Consultee Comments - Urban Design

Consultee:	BNE – Urban Design
Reference Number:	23/03204/OUT
Proposal:	Outline application (with all matters reserved) for the demolition of existing buildings and structures and redevelopment of the site for a new local centre (E (a-f), F1(b-f), F2(b,d)), open space and employment (office and laboratory) floorspace (E(g)(i)(ii) to the ground floor and employment floorspace (office and laboratory) (E(g)(i)(ii) to the upper floors, along with supporting infrastructure, including pedestrian and cycle routes, vehicular access, car and cycle parking, servicing areas, landscaping and utilities. (The Development is the subject of an Environmental Impact Assessment)
Site Address:	Beehive Centre Coldham's Lane Cambridge CB1 3ET Cambridgeshire
Case Officer:	Cuma Ahmet
Responding Officer:	Sarah Chubb
Date:	09.11.23

Fig 1 – Red arrows shows the inconvenient detour for pedestrians and cyclists, yellow arrows illustrates the natural desire line.

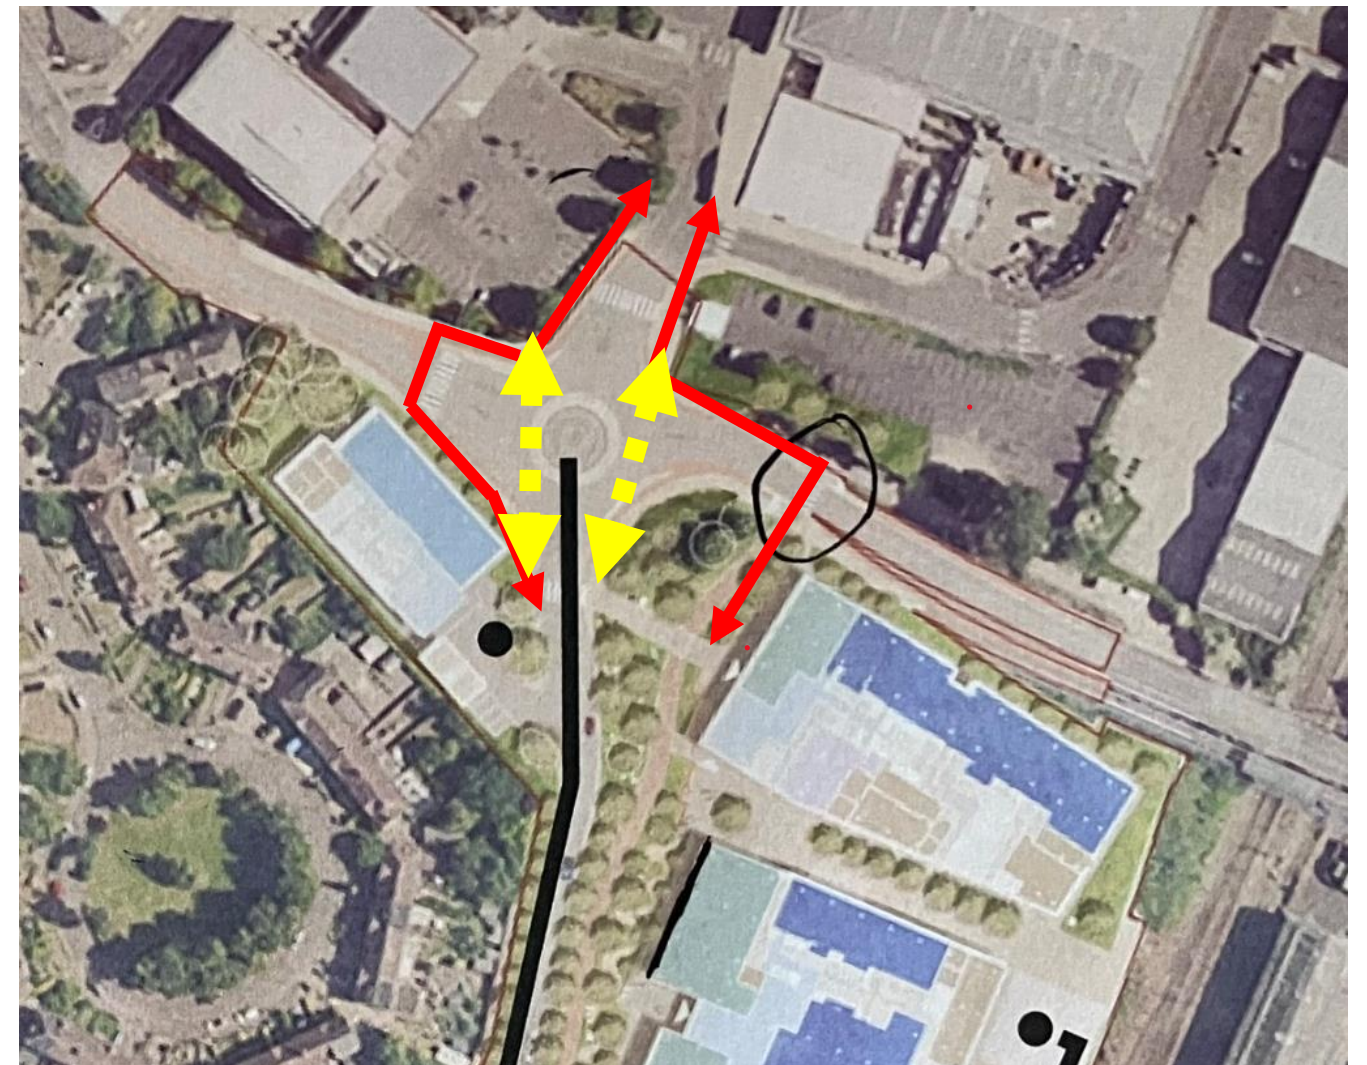
The proposed outline for the Beehive Centre is arguably one of the most significant urban renewal projects since CB1 and when considered alongside the redevelopment potential of Cambridge Retail Park, it presents a once in a generation opportunity to re-imagine the busy and traffic dominated highway of Coldham's Lane. To change it from a "main road" condition into an urban street; with the goal to make it more comfortable and convenient for people to walk along and cross. We are therefore disappointed and concerned that the proposed access will continue to be facilitated by a roundabout.

In our view this is the wrong approach; it is a standard highway solution that is land hungry, prioritises vehicles, maintains the current uncomfortable pedestrian and cycle environment and will undermine the expected modal shift towards more active travel. Maintaining a roundabout, continues to create wide sweeping junction curves, which forces cyclists and pedestrians away from the natural crossing desire lines. This maintains the current, inconvenient detour for pedestrians and cyclists, rather than attempting to address the problem. (See fig 1)

Spatially, the proposed roundabout concept is having a negative impact on the positioning of the buildings which are responding to the geometries of the road by following the wide, land hungry, cut back corners. This means that the "road" will define the space at the junction rather than the buildings which will create a weak and poor continuity of building line along the key frontage of Coldham's lane, a leaky and poorly defined key arrival space (see further explanation under section 3) and is pushing Plot A close to the existing residential boundaries of Silverwood Close.

A simpler junction arrangement with tighter radii corners would form a better approach for people and place. It would allow pedestrian/cycle crossings to be located on the junction to respond to desire lines; help to reclaim space so that Plot A could be arranged to help create a stronger building line along Coldham's Lane, to better hold the junction and help to create more breathing space between Plot A and Silverwood Close properties. These changes are indicatively shown on our alternative spatial layout. Given that the application claims reduced motorised vehicle traffic movements on Coldham's Lane, we see no reason why this cannot be achieved.

Fig 2 – Extract from the submitted Design and Access Statement, which shows the sprawling local centre gravitating to the northwestern part of the site.

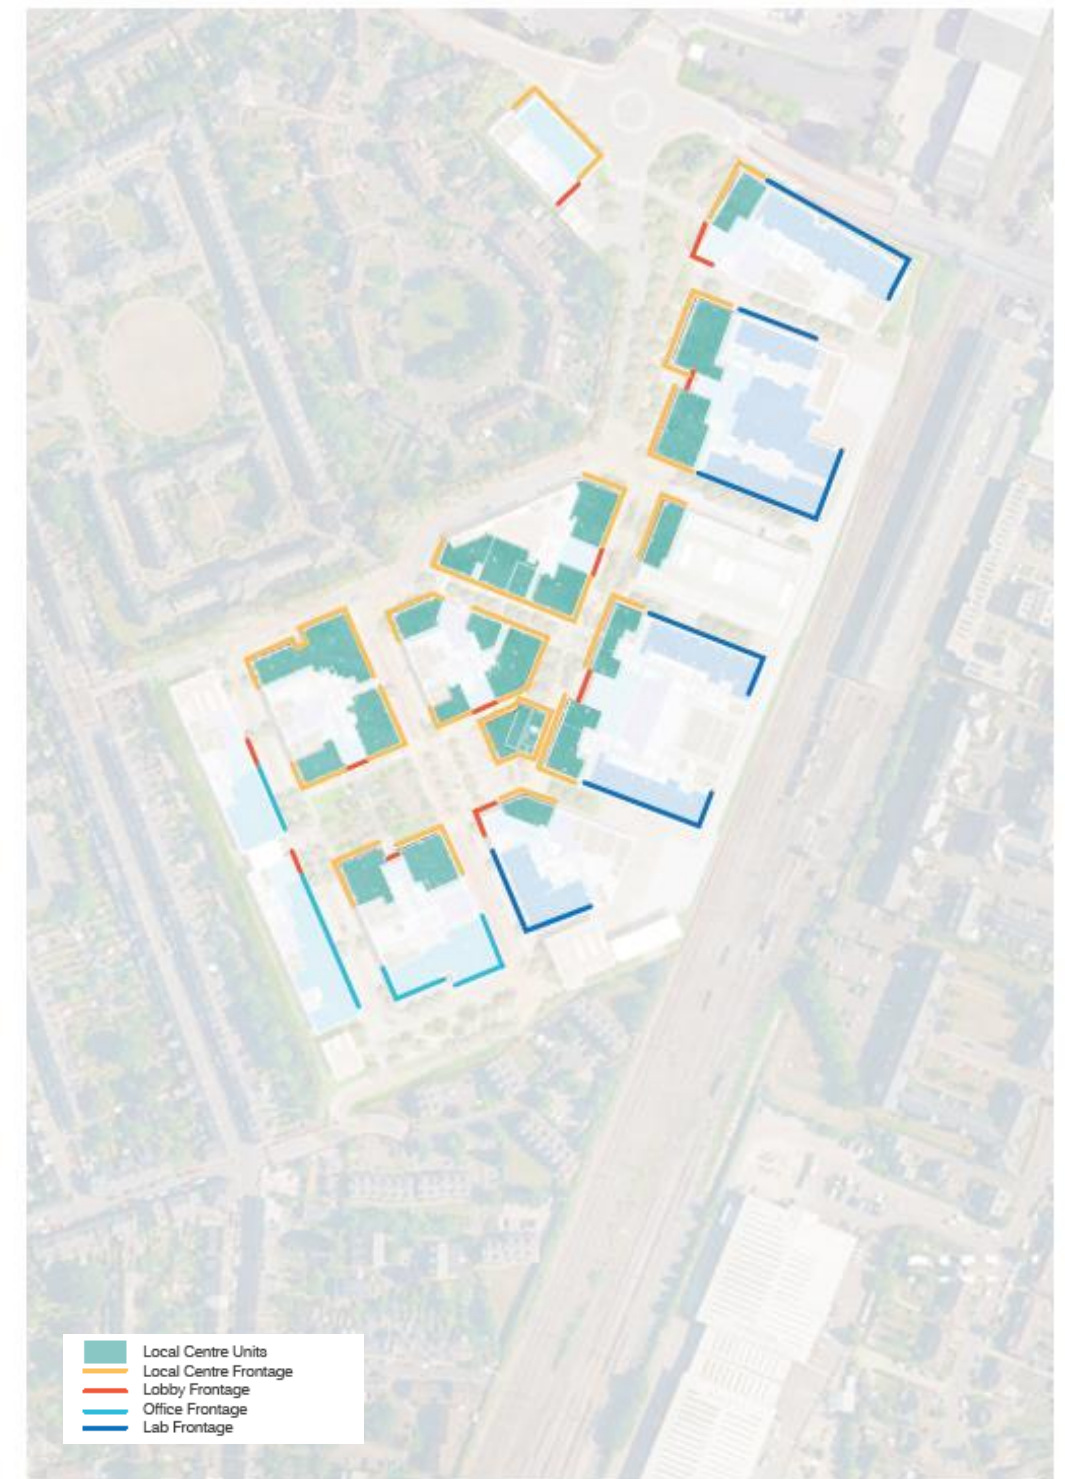
The masterplan incorrectly assigns equal weighting to these two existing pedestrian and cycle access points from York Street and Sleaford Street into the southern part of the site. This is producing a confused spatial street hierarchy, lots of hard vehicle circulation space that penetrates deep into the site, fronts and back issues along the northern western edge and an indirect main cycle link through the site. As a result, the main spine route through the site - which should be to the southwestern corner - is weak in legibility, and the footfall intensity or “heat” on this route will be watered down.

These structural movement problems is impacting upon the extent of local centre uses and frontages, which has overspilled and gravitated towards the northwestern part of the southern area of the site, further muddling the hierarchy of routes and spaces. The fundamental spatial layout proposed needs to be revisited. We have set out an alternative approach (see page 9 of comments).

We believe that a much stronger spine route through the site to the southwestern corner needs to be created; a direct and spatially legible route for both cyclists and pedestrians between Coldham’s Lane and Sleaford Street, that reflects the main desire line through the site, providing the focus for a rationalised and more consolidated “high street”, that in turn creates a more intense “hot route” of activity. Furthermore, the rationalisation of the ground floor retail space will help to absorb some of the loss of workspace that will need to occur to address scale and massing concerns.

Fig 3 (top) and Fig 4 (bottom) highlight the poor levels of visual permeability and wider legibility issues stemming from the proposed spatial layout.

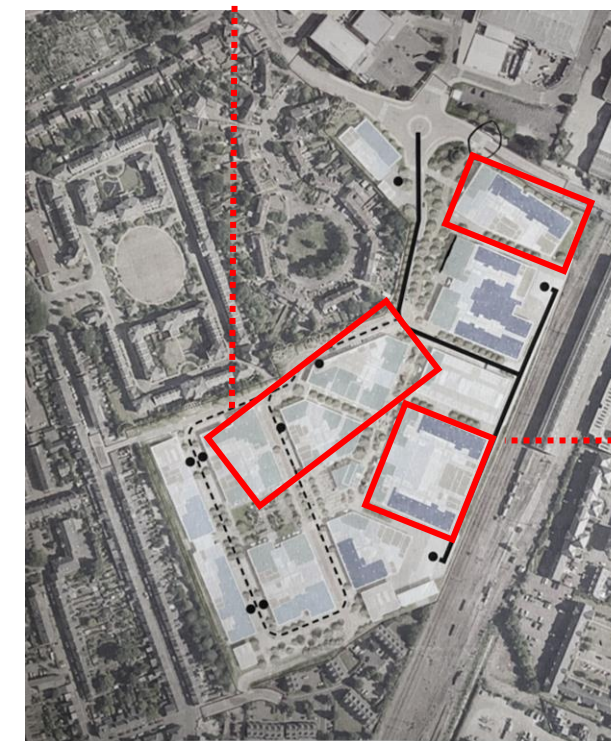
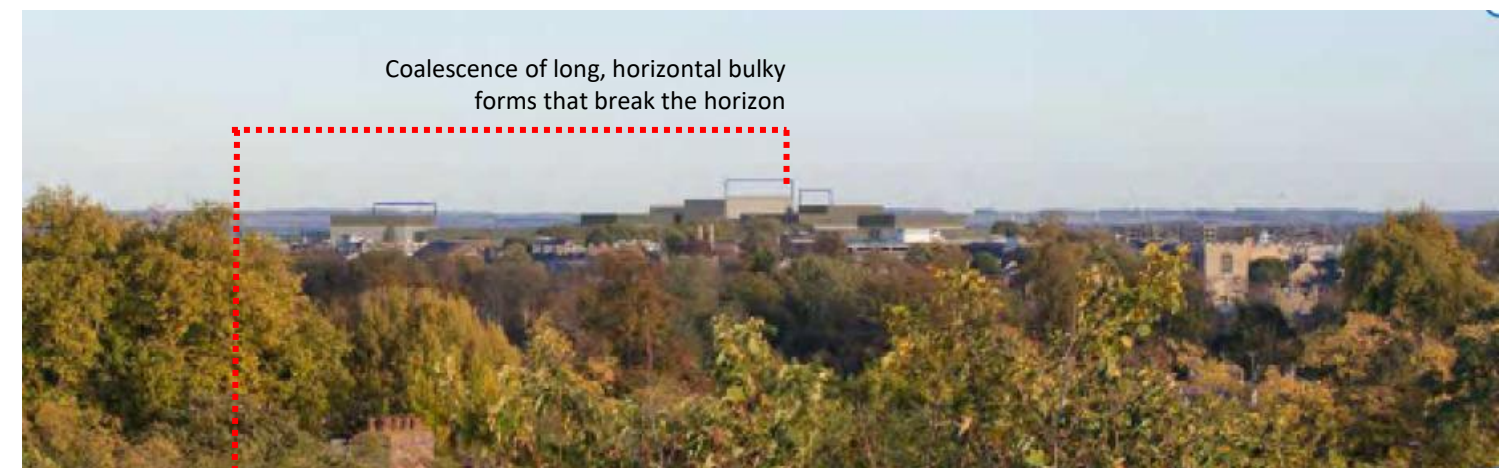
(a) Poorly defined arrival space (Abbey Grove) – The proposed key arrival green space is “leaky”, poorly defined and fails to connect to its surroundings in a coherent way, creating poor levels of continuity and enclosure both along Coldham’s Lane and into the site. Legibility is poor within the long linear open space; the CGI looking south towards Block M, illustrates how it is unclear where the main street with is. Re-imagining the roundabout as outlined in section 1, will help to create the potential for better continuity of building line along Coldham’s Lane and a tighter entrance into the site. Though our revised approach, we have introduced a defined square as a key move to address these issues, to positively anchor the arrival sequence into the site and terminate the northern end of the high street. The “mouth” between Plots M and Plot 3 has also been widened to improve visual connectivity and wider legibility.

(b) Dead-end destination space (Garden Square South) – The ambition to create a new civic scaled space is welcomed, however we are not convinced that the location of the key public space (Garden Square S) is positioned or integrated into the masterplan in the right place. As proposed it terminates the end of what is meant to be the main street but doesn’t naturally go or lead anywhere. When considered with Garden Square N, the orientation doesn’t reinforce the natural line of direction through to the Sleaford Street (SW corner) which is a key integration and access point into the surrounding community. Sunlight access will be affected by Plot H to the south. The concept of the wetland planting is interesting, but any SUDs feature needs to be part of a larger space. The current illustrative concept means that the wetland area will take up most of the space, limiting activity to the edges. A city scaled destination space, should be the instrument for urban transformation, working as an integration tool to create a sense of continuity with the wider context. It would be better to amalgamate the spatial area of Garden Square South and Vera Gardens, to create one larger destination “park” space which would reduce competition for use and accommodate strategic tree planting.

(c) Southern entrance space (Vera’s Garden) – The southern open space feels confused and like a back door entrance to the proposal. The wide and shallow space is flanked by the existing wall and cycle stores; the southern façade of office Plot H does not balance this shallow space. Vehicle circulation pulling into the SW corner running in front of Plot H, further compromises this already constrained space. The CGI image on page 48 of the DAS offers little comfort; which demonstrates how the space fails to contribute to a wider legible structure. The proposed allotment use feels like an afterthought to try to give this space meaning.

Fig 5 – Illustrative masterplan proposal from rear garden of 52 York Street

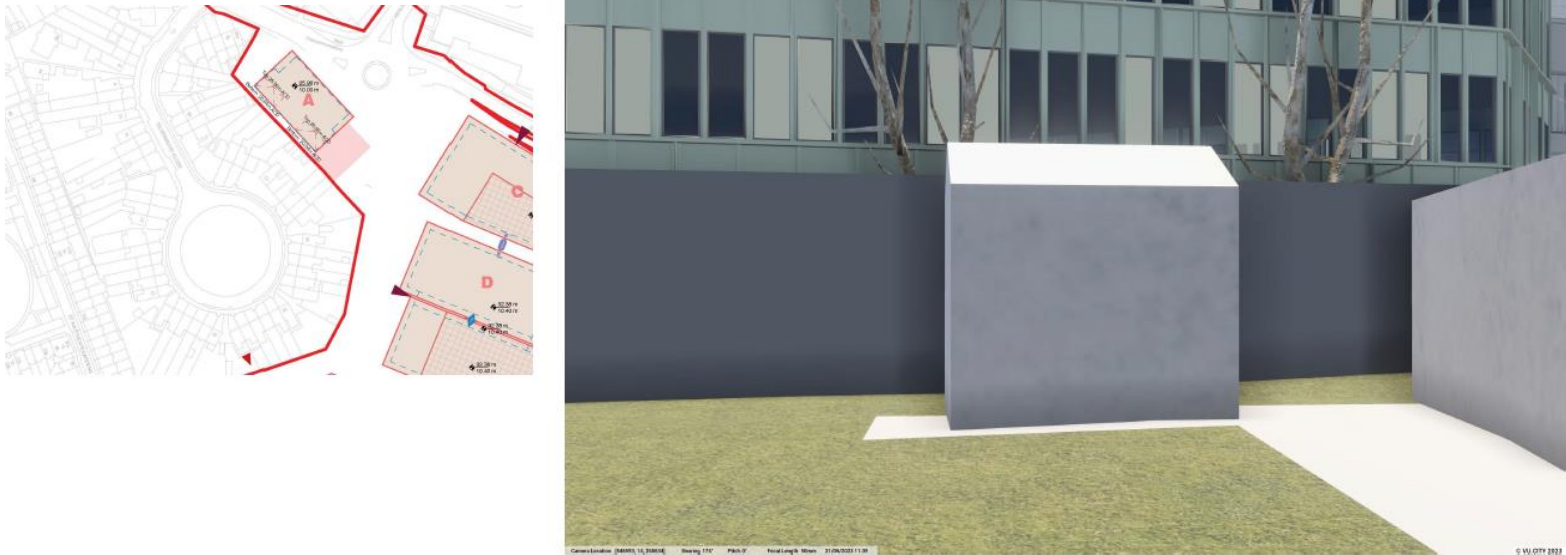
The proposed upper limit of 20.2m proposed for Plots I and J is of concern, which will create an unacceptable overbearing impact when viewed from the rear gardens of York Street. Therefore, to create a more comfortable relationship the upper limit of these blocks should be fixed at 15.1m, and the inclined slope parameter extended across the entire length of these buildings. The existing, mature green edge along Rope Walk, currently provides an effective screen between properties and the existing beehive buildings and will be important to mitigating the impacts of a change in scale and mass around this part of the site. It is unclear whether the proximity of the proposed plots has been determined with the objective to safeguard the health and therefore the current screening effectiveness of the existing vegetation in addition to any of the assumed works. Further clarification is needed.

The proximity of Plot A which sits tight to the rear boundary of Silverwood Close and the length of the northern edge of Plot M is of concern, which according to our modelling work will create an overbearing impact. As indicated on our alternative approach, a better relationship could be formed by pulling Plot A away from this boundary and shortening the length of the northern boundary of Plot M so that it reflects the length of the terraces found in Silverwood Close.

Proposed outline application – Coldham’s Common

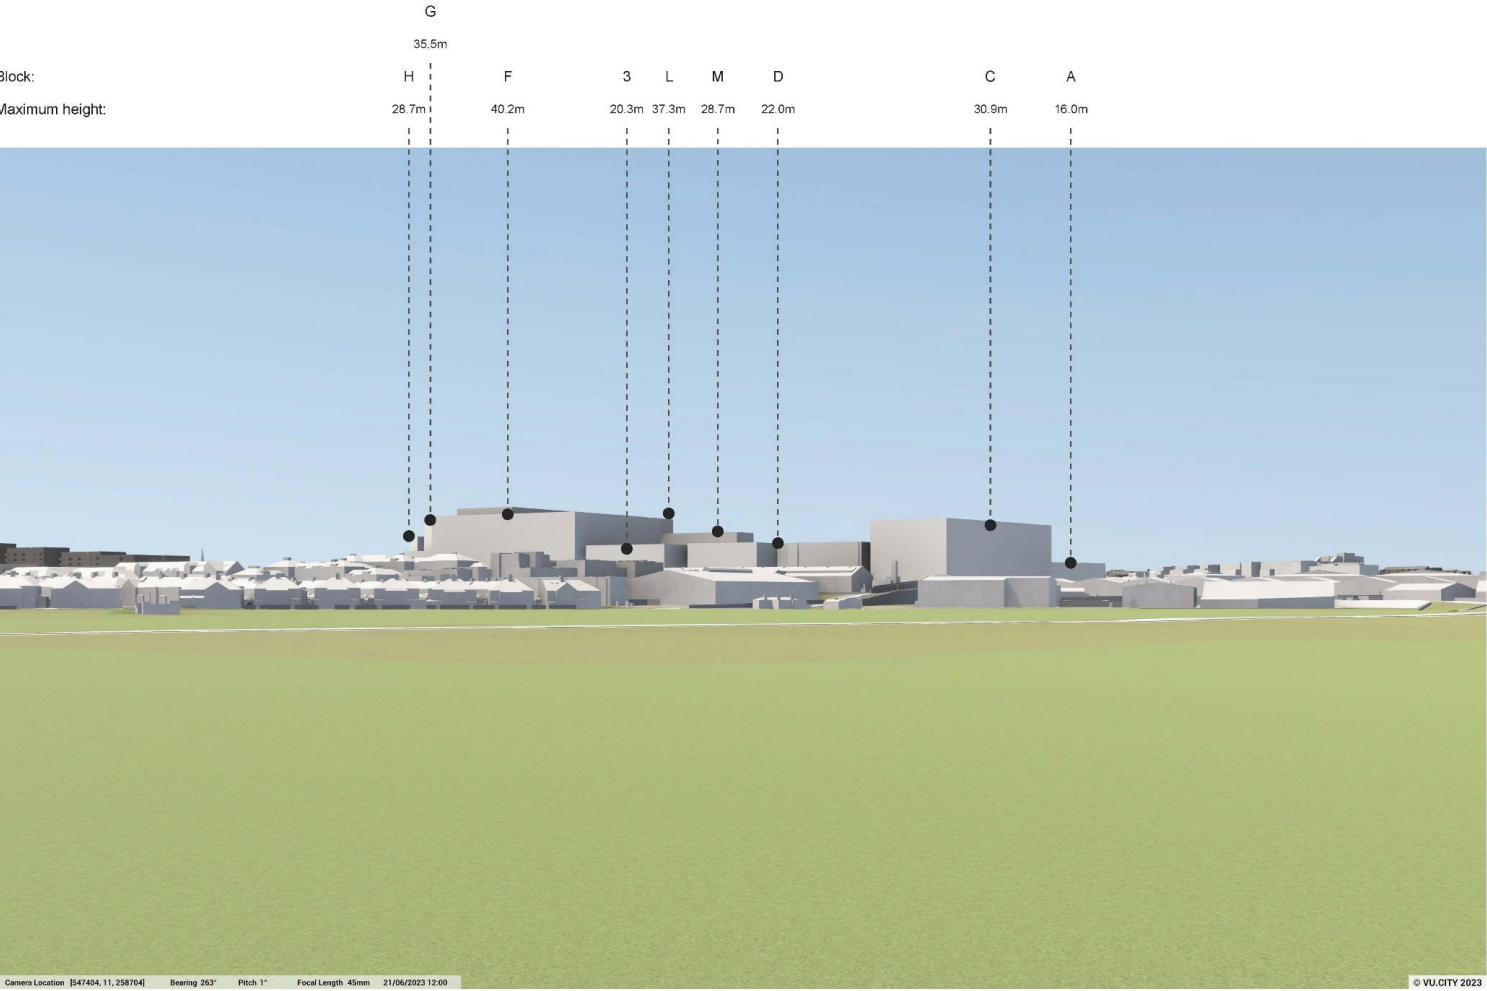
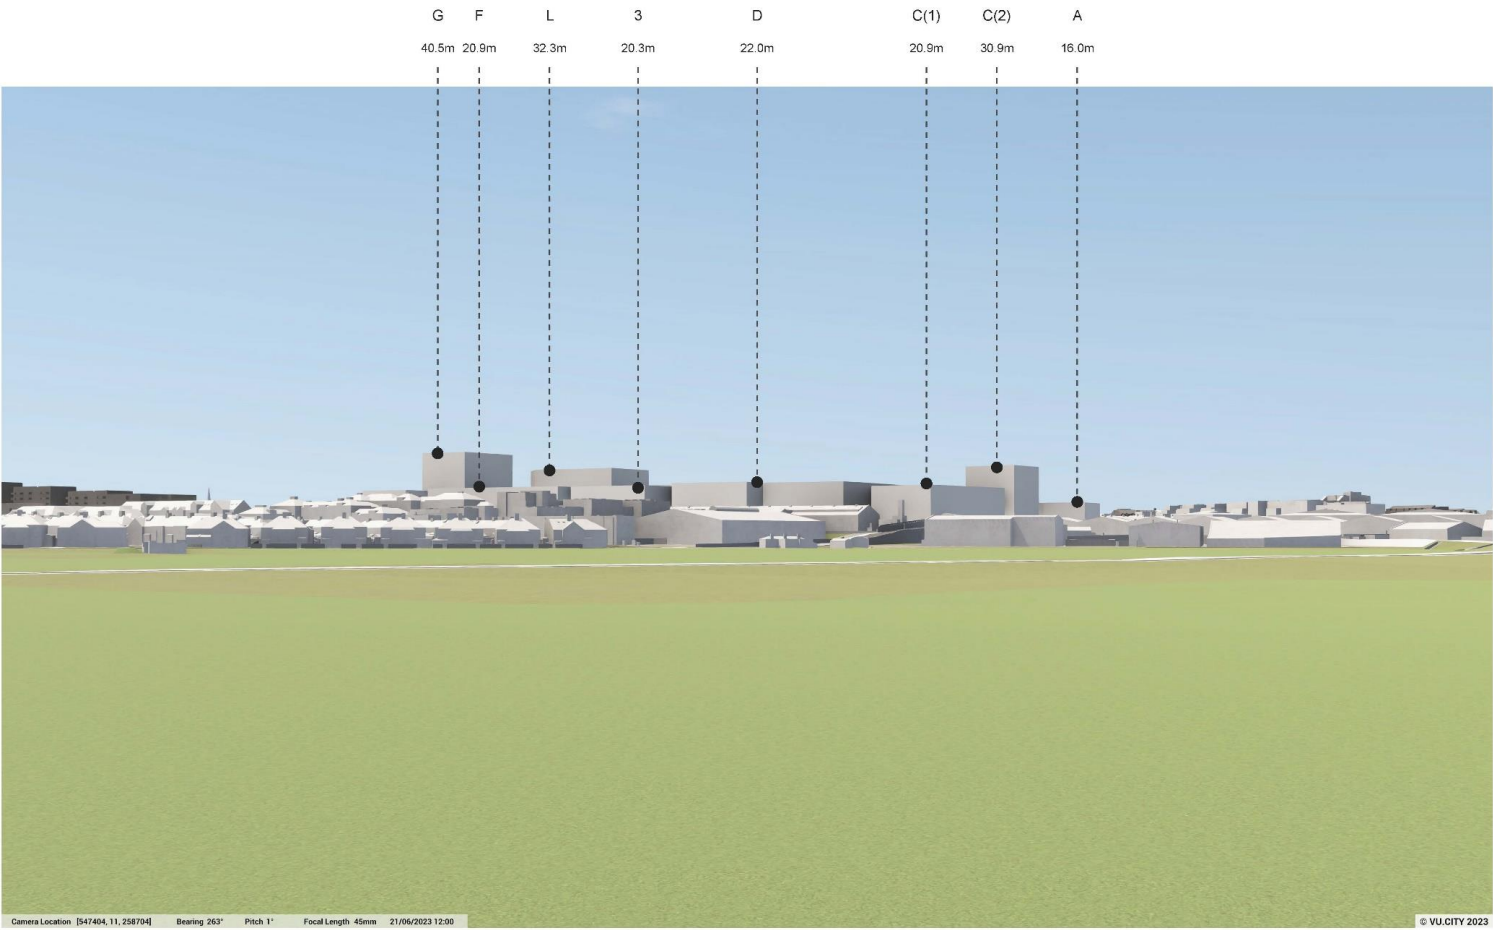
The following pages set out an alternative approach for reorganising and re-imagining the site in a way to respond positively to our concerns, other technical consultees and the community. The suggested layout and massing strategies are given without prejudice, providing alternative concepts and approaches for further design development and testing through verified views, including additional viewpoints from the rear gardens of existing residential properties.
